NN-P-71C
Int. Amendment - 2 (SA)
2 May 1977

FEDERAL SPECIFICATION
PALLETS, MATERIAL HANDLING WOOD
STRINGER CONSTRUCTION 2-WAY AND
4-WAY (PARTIAL)

FIGURE 12. Type VII, two way flush pallet (dimensions shown for group I and II woods).

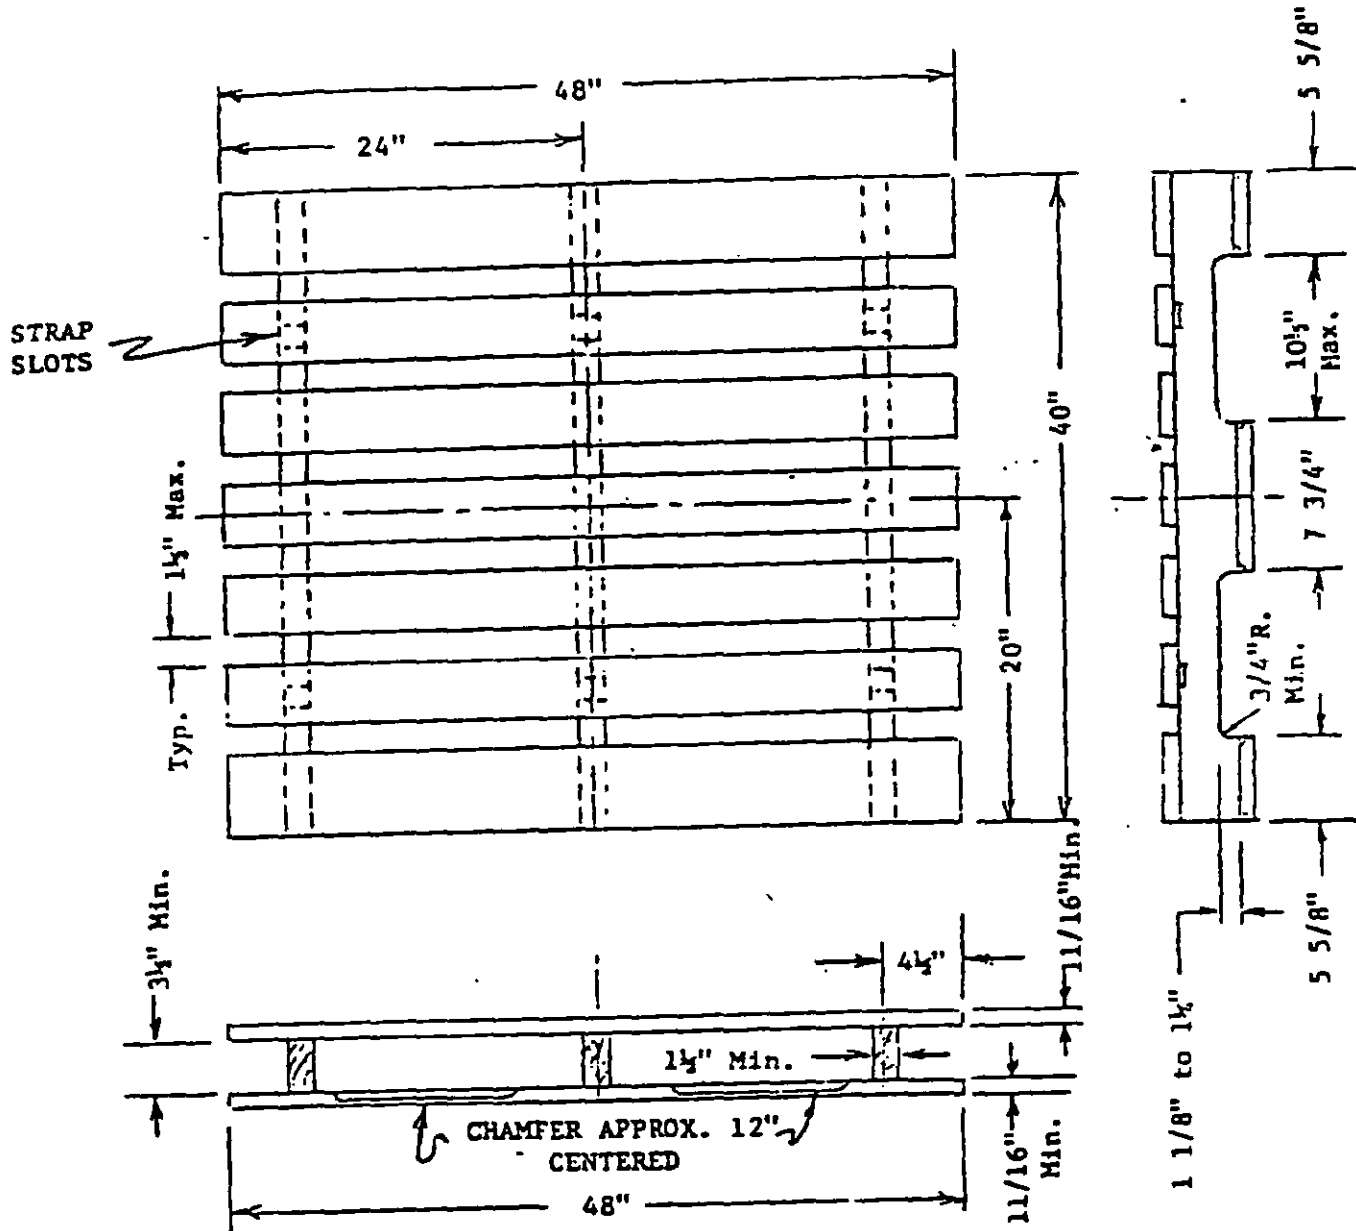
1.2, after Type VI and before Group I, add: "Type VII - Two-way, flush, assembled, nonreversible, single-use, 44 X 44 (see Figure 12)." and "Type VIII - Four Way, Partial, Wing, Nonreversible, Single Use, (see Figure 13)."

3.4.2.2, ~~Line 9~~, delete period after fourth sentence and add: ", except that for Type VII pallets the deckboards shall be not less than 3-1/2 inches wide."; line 12, place a comma after "3 inches" and delete: "and"; line 13, after "Figure 9", add: "and Type VI pallets shall be equally spaced as shown in Figure 12."; line 20, change complete sentence to read: "Type IV, VI, and VII pallets shall not have chamfers."
